PLANNING & DEVELOPMENT SERVICES MEMORANDUM

RE: **(#22-02) Bannerman's Sportsgrill – Sound Study**

Bannerman's Sports Grill Outdoor Venue Sound Study

Bannerman's Sports Grill Outdoor Venue Sound Study Addendum 1

Figure 1 - C-weighted sound contours with stage wall, stage rotation, and a 92 dBC limit at the mix station (Nighttime)

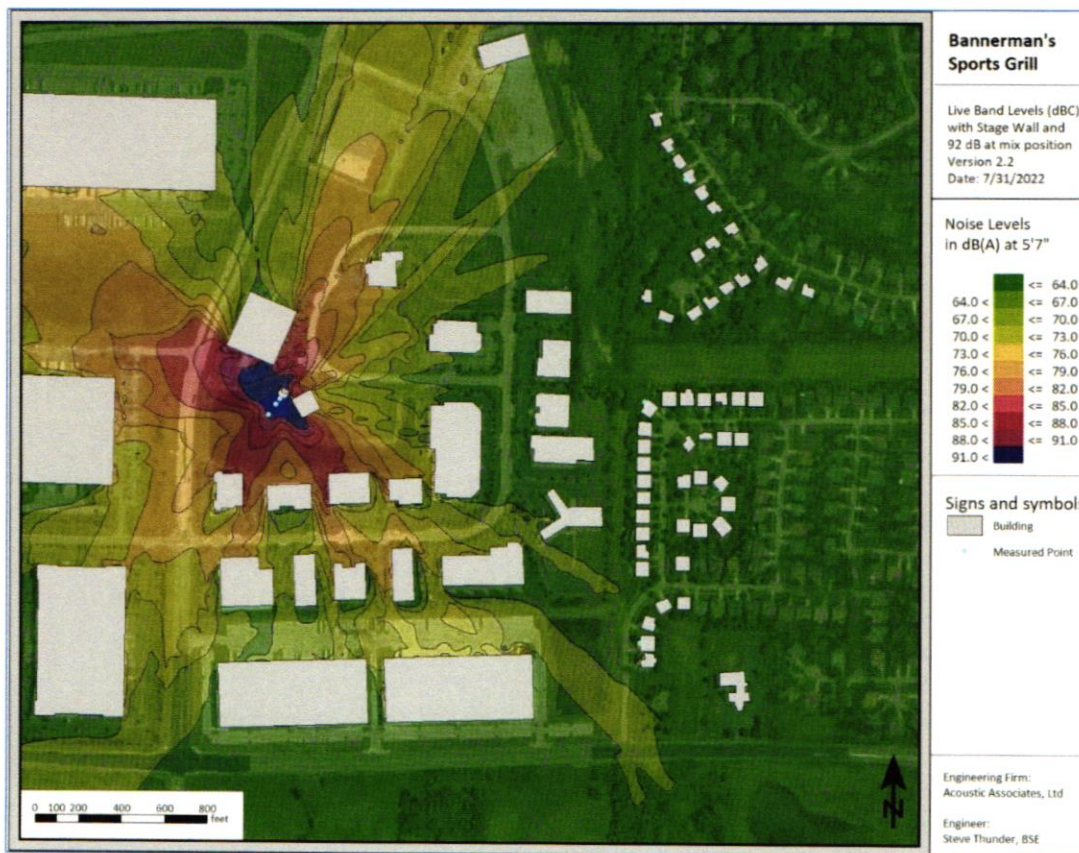
The petitioner has agreed to rotate the stage 5 degrees clockwise, install a sound stage and reduced the sound level limit to 92 dBC at the mixing station. While Figure 2 in the addendum indicates a sound level of 98 dBC during daytime hours, the petitioner has agreed to the reduced limit of 92 dBC at all times (see Figure 1 in the addendum for the sound contours).

- B. Rotate the stage 5 degrees clockwise and install a sound wall on the east side of the stage as recommended in the sound study addendum #1 prepared by Acoustics Associates, Ltd dated August 1, 2022.
- C. The band sound level at the mixing station shall not exceed 92 dBC at any time. The sound engineer shall determine the Leq of the music based on 15-minute periods. This measurement shall be done on an hourly basis. Logs of this data shall be kept for Village review.
